AGENDA OF THE PLANNING  
COMMISSION  
CITY OF BIRCHWOOD VILLAGE  
WASHINGTON COUNTY, MINNESOTA  
May 25th, 2023  
7:00 P.M.

MEETING MINUTES (Draft)

**Meeting Date(s):** May 25, 2023 Planning Commission  
June 2023 City Council

Report prepared by Ben Wikstrom, Planning Consultant

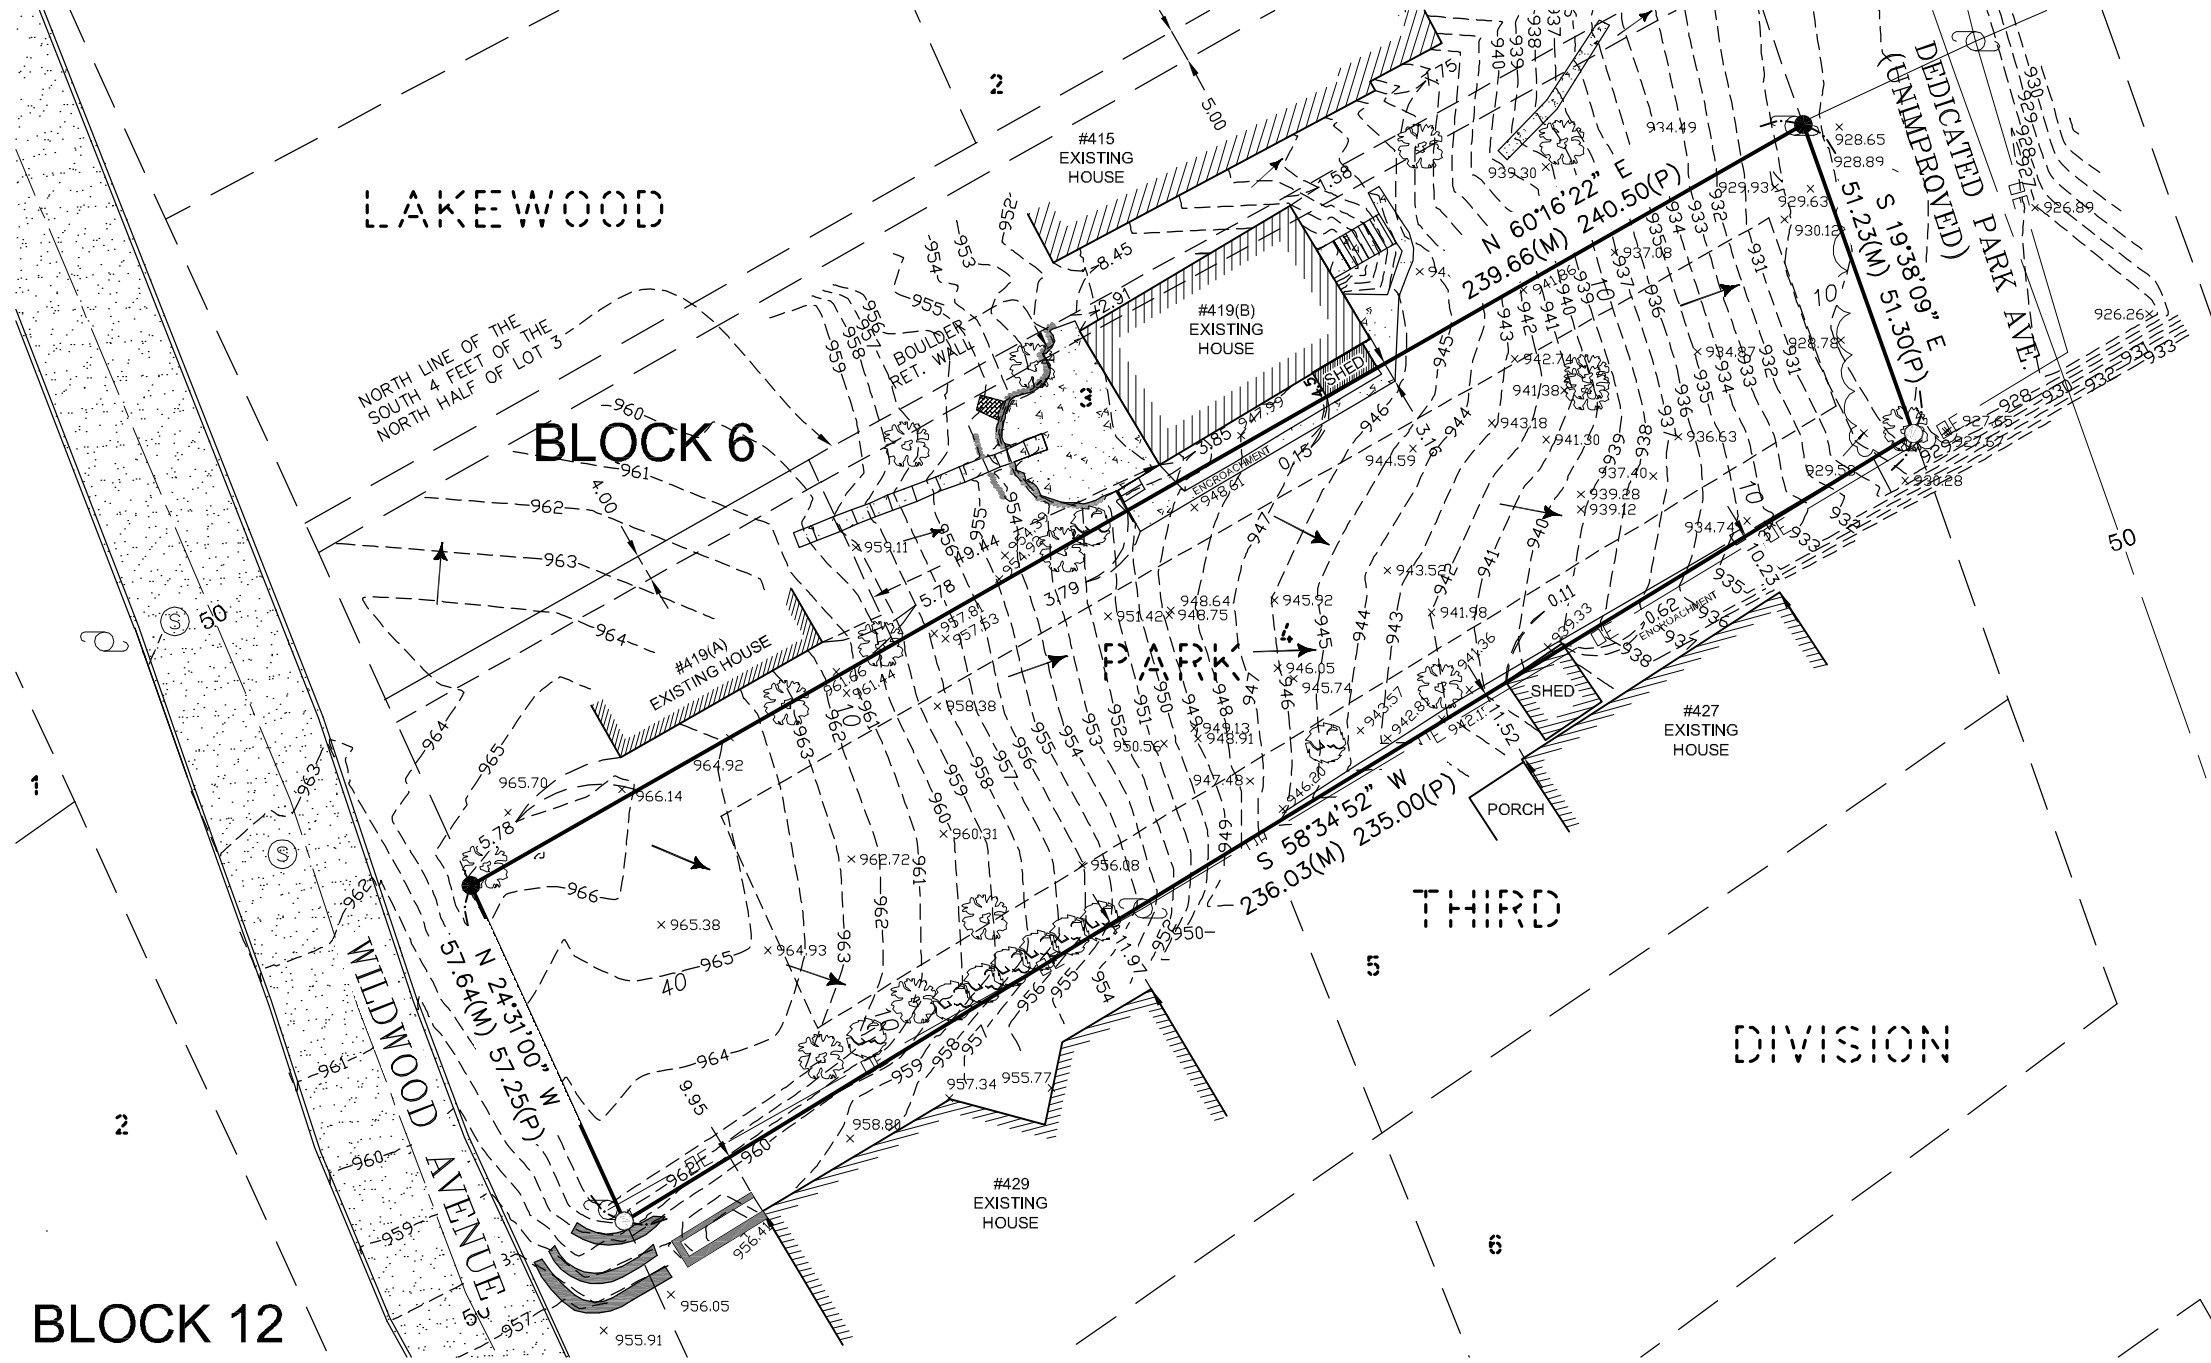
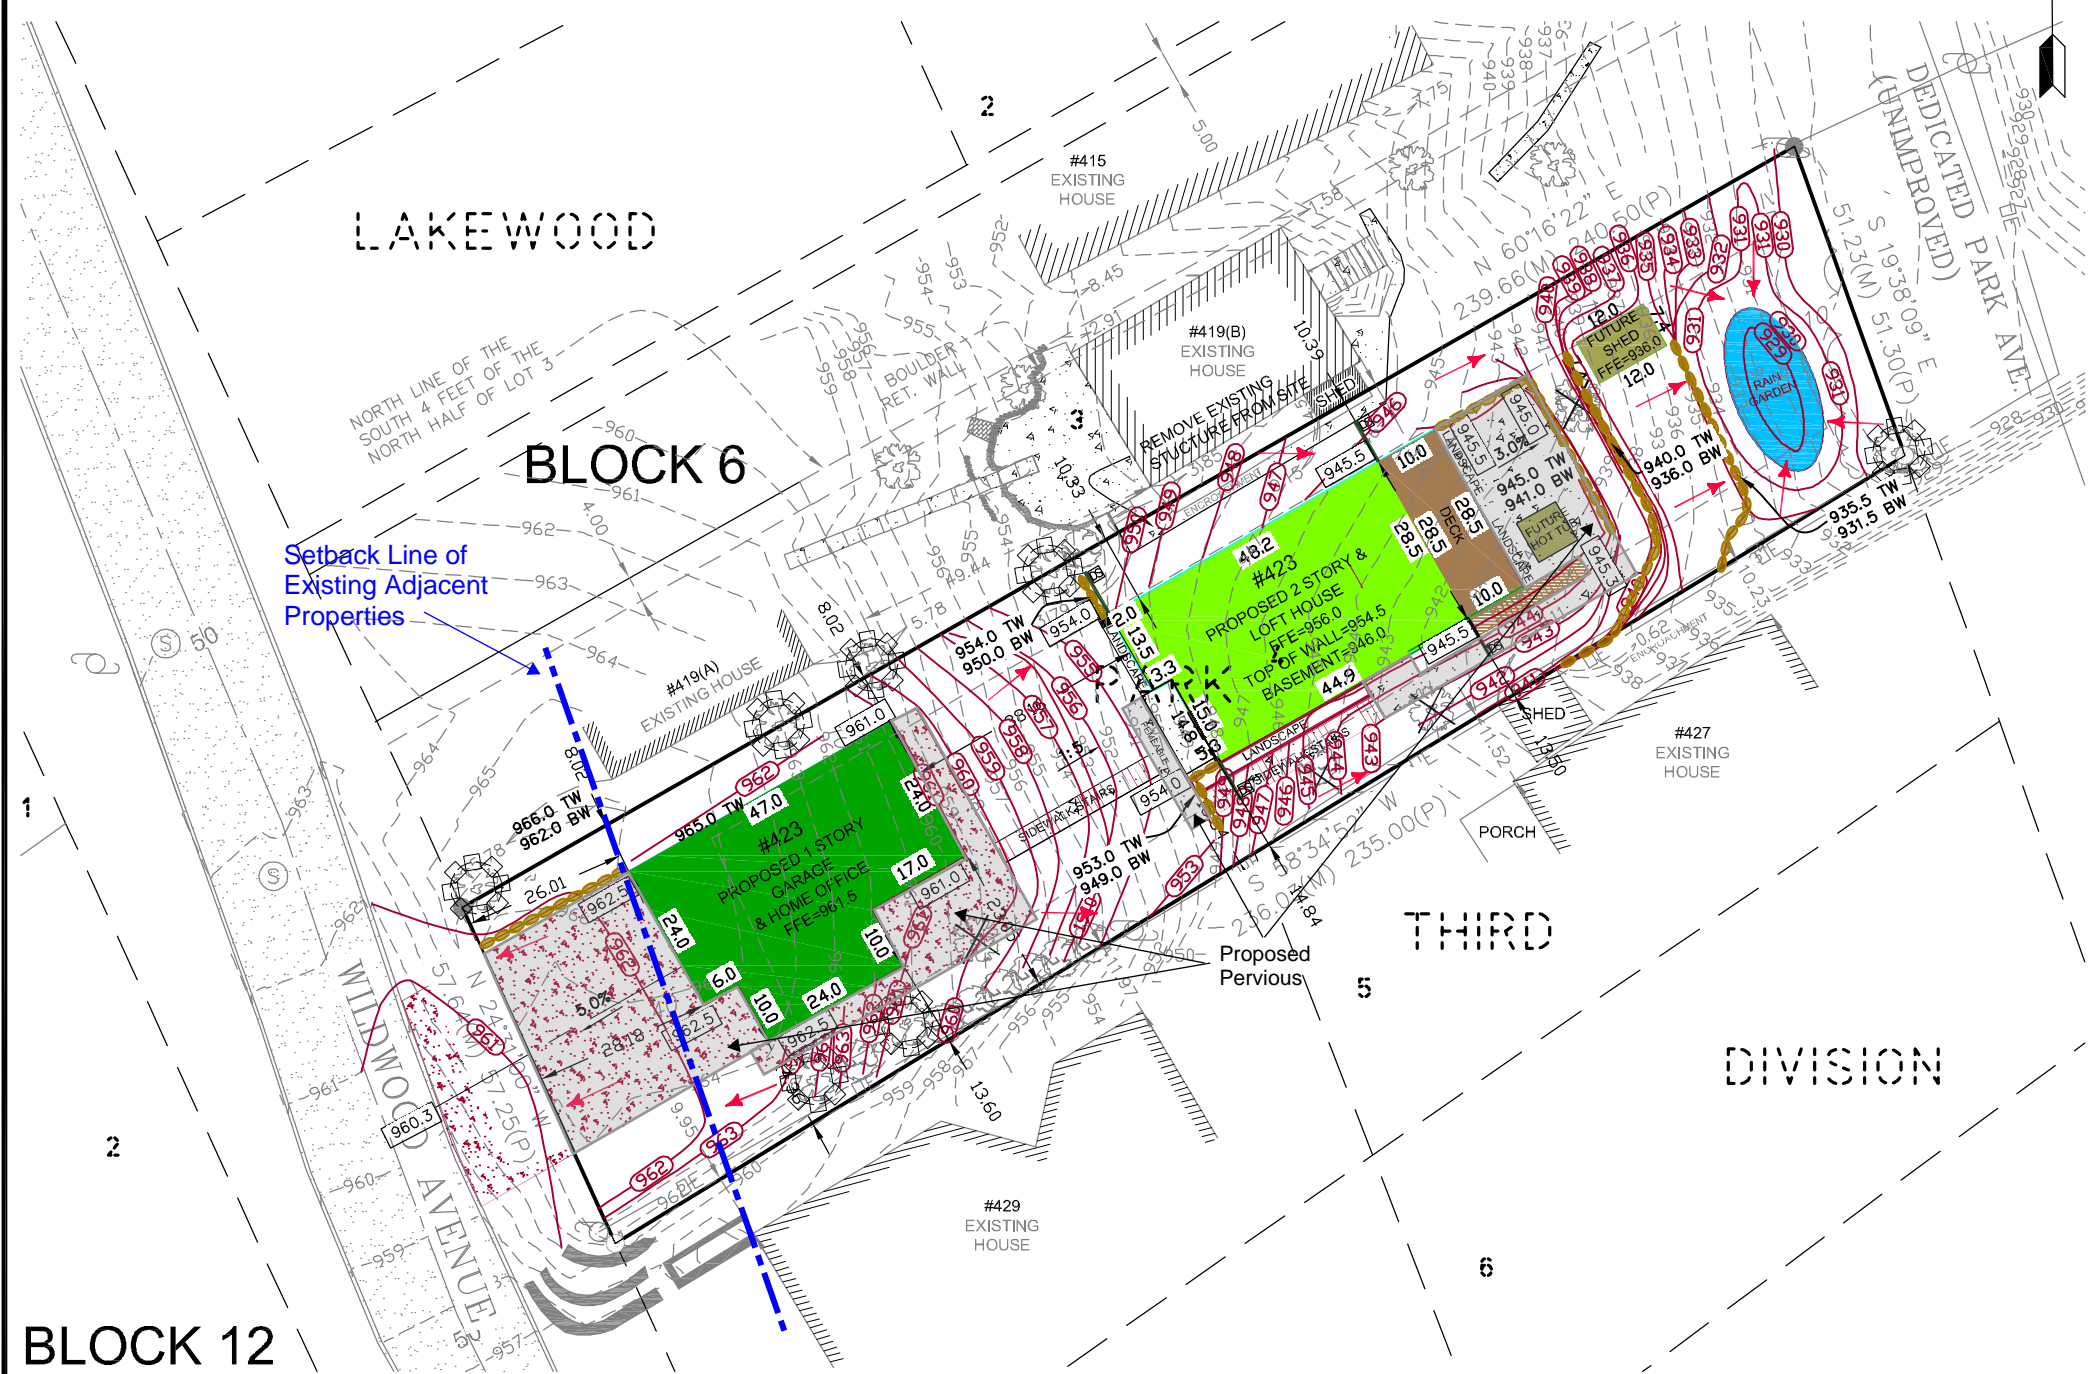
The proposed location of the structure is in line with neighboring structures along Wildwood Avenue (the blue line on the site plan excerpt above shows the line). With the spacing from the house and steps needed to descend the slope, the front setback is seen as reasonable and the variance request results from the natural grade of the site.

The side setback on the north side is not out of character for the neighborhood, and even the adjacent properties. There is room to have a conforming (as it pertains to the side yard setbacks) location, as explained in the staff comment section at the end of this report. The character and reasonableness "tests" are met with the proposed location, while the practical difficulty of the north-south placement should be addressed by the applicant.

The only practical – from a location standpoint – solution would be to remove the office from the rear of the garage and locate the structure further from the road. However, the applicant is within the impervious limits allowed by ordinance (so a building of the proposed size is allowed), and the aforementioned surrounding uses seem to make the proposed location reasonable.
